Up-date of CD-Player A727 when using the PARALELL CONTROLLER 1.630.900.00

Instructions for Hardware Modification on SERVO board 1.769.410.20

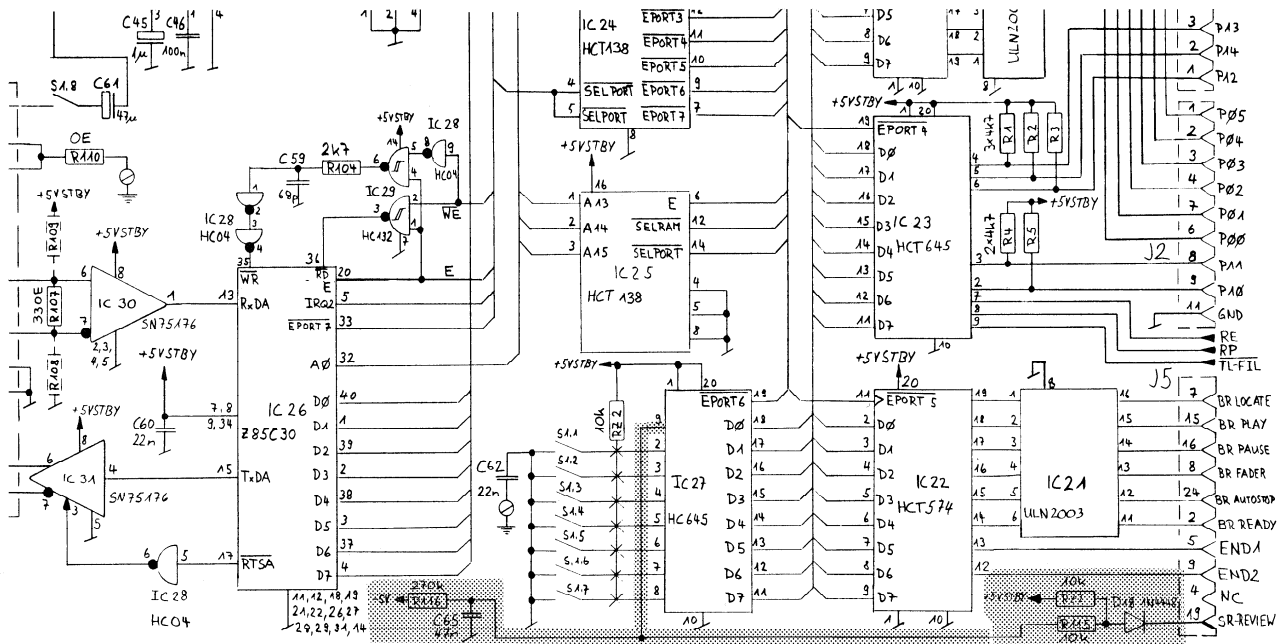
Before putting in operation please pay attention to the following flow chart:
